Wisconsin Department of Transportation

Proposal #48: 5845-16-84, WISC 2026055
Stoughton – Madison
Tower Road To Exchange Street
USH 51
Dane County

This is Addendum No. 01, which provides for the following:

ADDENDUM NO. 01

Addendum No. 01
ID 5845-16-84
Revised Sheet 98
December 4, 2025

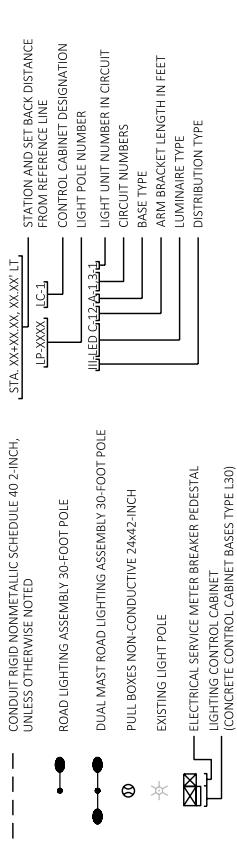
Revised Plan Sheets	
Plan Sheet	Plan Sheet Title (brief description of changes to sheet)
95	Lighting Plan (Updated to add pull boxes in the splitter island and one additional light pole assembly.)
97	Lighting Plan - Wiring Diagram (Updated to add pull boxes in the splitter islands and one additional light pole; updated wire size in conduit crossing north of the roundabout.)
98	Lighting Plan - Wiring Diagram (Updated wire size in conduit crossing north of the roundabout.)
181	Miscellaneous Quantities (Updates to lighting summary tables.)
182	Miscellaneous Quantities (Updates to lighting summary tables.)
